Technical design note

Project name	Land North of Rectory Farm, Yatton		
Design note title	Response to IDB Comments dated 15th May 2023		
Document reference	23257-HYD-XX-XX-TN-D-0002		
Author	Richard Hughes		
Revision	P02		
Date	7 July 2023	Approved	✓

DWG DA 1

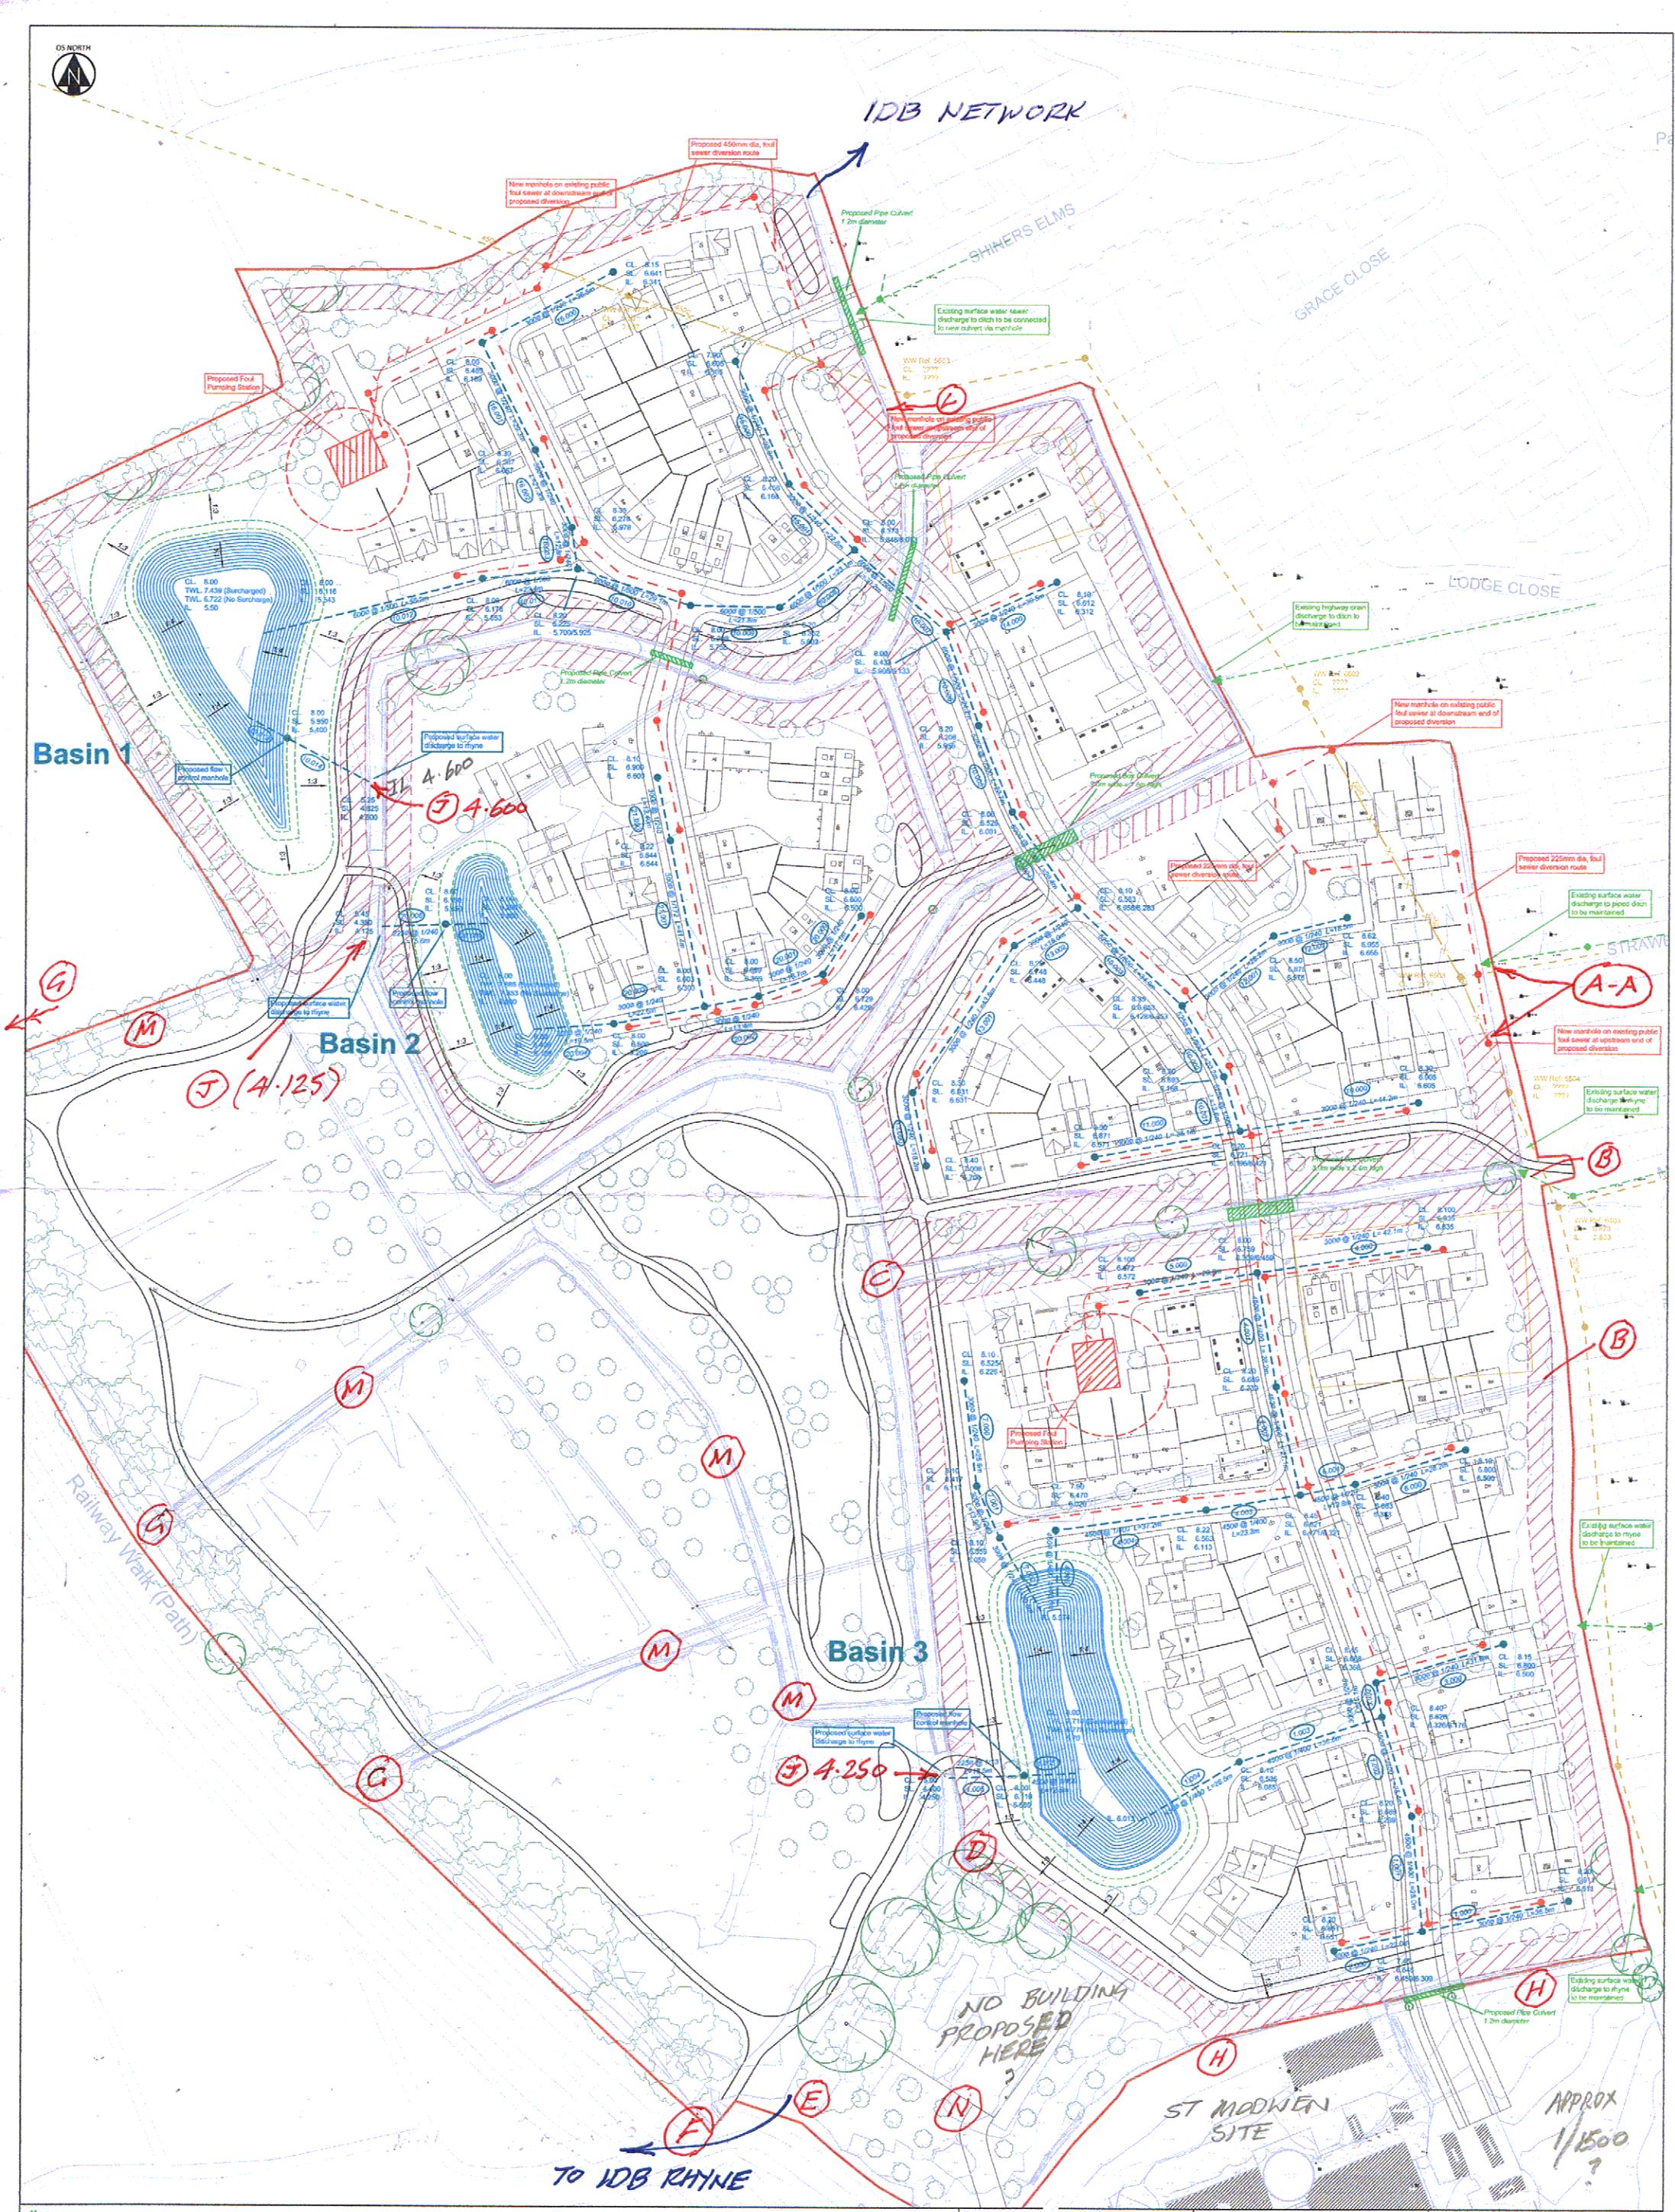
AA The length of watercourse between the two points indicated runs southwards and cannot be accessed from the East side. The proposed access requires extending accordingly to ensure clear discharge path for the SW outfall.

B The IDB SW pipeline may be situated further from the boundary than indicated on dwg 2002 and has a concrete outfall into the IDB rhyne at its N end and two screened connections from SW drains and the boundary ditch along the existing development to the East. The pipe run is to agricultural standard and this, the outfall and connections should remain accessible and safeguarded from interference. The integrity of the pipeline with an extra 2 or 3m of surcharge should checked.

Where the IDB pipeline enters the head of the E-W rhyne a town outfall may require a headwall depending on ground level proposals.

The structures are not apparent on the Hydrock survey sheets.

The IDB pipeline and existing ditch along the western boundary of the existing development captures and routes away town surface water which previously caused parts of the eastern edge of the proposal fields to remain permanently wet. A section of the boundary has no positive drainage at present and to ensure that the ground raising does not obstruct the ground water further land drainage measures may be required. A plan and sections through the Eastern boundary showing proposed ground levels, boundary treatment and drainage details is required to assess this.

BC This length is IDB adopted and maintained. A sketch cross section of the proposed arrangement has been provided but the width between the tops of the slopes (approx 32m?) does not appear to be replicated on the plans? of watercourse

C-D-E This length of watercourse has previously been maintained by the farmer in liaison with the Board. It routes surface water from the souther part of the site to the head of the IDB system at F. Access strip will be required from D to E which owing to mature trees along the SW side of the ditch will need to be along the NW side, currently and proposed to remain as open field. Any tree planting should be a min of 9m from the watercourse.

Between E and F it is understood a culvert connects to the NE railway ditch, conveying SW to the head of the IDB viewed rhyne system which terminates her at the West side of the railway embankment . Details are not known but it is probable reconstruction will be required. It is possible that The adjacent St Modwen site will also require this culvert to be effective.

There is a separate brick culvert under the railway embankment which is kept clear by the IDB.

As the section CDE also serves third party interests it may be appropriate for the IDB to adopt this, once the developer has brought the complete length up to adoptable standard. I have inspected this and could provide a specification, including bed levels etc If adopted a wider access strip would be required between C and D and extended from D to E, but this could be along the West side from C to D which is clear of the housing zone.

Will the manure heaps be removed?

None of the remaining ditches serves third party developed land so that responsibility for maintenance could remain with the developer.

E-F The existing connection here involves the railway culvert and a further gateway culvert (????). If present the latter may require replacement.

G-G-G Need to ascertain whether these are connected into the railway ditch and if so whether they require to be effective, or does the water flow eastwards.

H-H There is a ditch along this boundary cut by the former farmer. It abuts the Rectory F Modwen site. It is likely to be connected to the length HD but this needs to be investigated and if not, a connection should be established. The functionality of this drainage route needs to be maintained and responsibility for its maintenance established – ie St Modwen or Persimmon? It does not take water from existing

J The proposed invert levels of the 3 pond outfall structures are below penning level – this is not acceptable and I think would preclude adoption by Wessex Water.. Recommended minimum 4.85m AOD (150mm above SPL)

L My records show an extra outlet here.

M How will these ditches be maintained – the indicated tree planting is in places too close for machine access. Although not previously cleaned on a regular basis all minor farm ditches on low lying ground such as this require occasional attention to maintain conveyance and prevent the zone becoming swamp.

N Is this area to be left “as is”?
